Meeting Notes

January 31, 2023

Willow Island Park Enhancements Community Oversight Committee Progress Meeting

COLOR SCHEMATIC PLAN

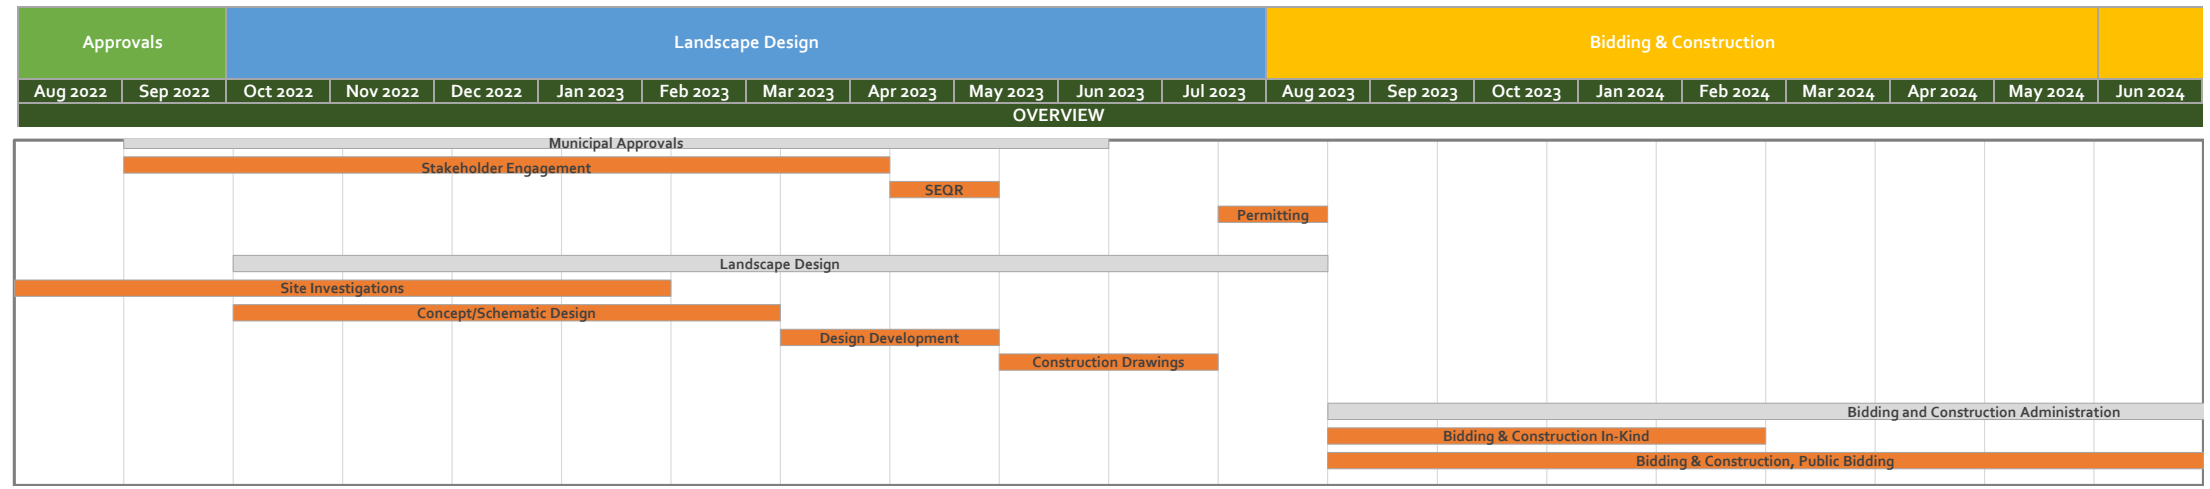
- Questions were posed regarding parking - it was determined that for an event most parking would happen off-site in municipal parking nearby, saving the parking lot for accessibility issues.

- Something to consider - put in something to discourage parking along the access road.
- It will be important to identify parking options and to have them ready to present at the public information session to answer people's concerns.

- It was confirmed that due to the floodplain any permanent structures would need some elevation which is difficult. Building on stilts would be theoretically possible.

- For the sidewalks, we would have to take away earth to put in the gravel or asphalt with amounts of earth moved calculated. Another theoretical possibility would be to construct a boardwalk.

- Maintenance issues for gravel vs. asphalt were addressed.
- The proposals for a performance structure or stage were discussed. There were some concerns regarding a stage that is flush with the ground. It is possible to raise it up slightly if earth were removed from somewhere else on the island. Possibilities for a temporarily raised stage that could be brought in as needed were discussed, as well as temporary bleachers for audiences as long as anything can be removed before flooding.

- Some discussion was held regarding how large the "stage" area would be. The design team would appreciate some feedback on this. Their placeholder is about 35 feet across at this time; the smallest it should be is about 30 x 30 feet. It would be possible to create a small stage area as proposed by Matthew Mazzotta, which could be covered by a larger portable stage as needed.

- One proposal involved the potential for leveling on the island to accommodate a skating rink or even digging down on the walkway to create a skating path (as long as drainage issues are appropriately addressed).

- Liability issues for the playground were discussed, as the owner of that portion of the site (Grasse River Heritage) would be concerned about this:
- As it would be a public playground on a not-for-profit property, a formal agreement with the Village to cover maintenance, usage, and liability would be recommended.

- In order to maintain the current timeline, the design team would like approval on their proposed layout (with any tweaks) within the next week or so.
- It is the intent that the project will be completed in phases, as funding will likely not cover the full design. The team will suggest phasing options.
- An opinion of probable cost will be developed for each program element once a layout is approved.
- Priorities will need to be identified based on the most desired coupled with what makes sense from a construction standpoint.
- Whitham will send the schematic design plan plus the bathroom cost analysis to the committee shortly. (Sent post-meeting)
- Next Meeting Scheduling:
 - February 23, 2023 at 4 pm - Committee Meeting
 - March 2, 2023 from 4-7 pm - Public Information Session
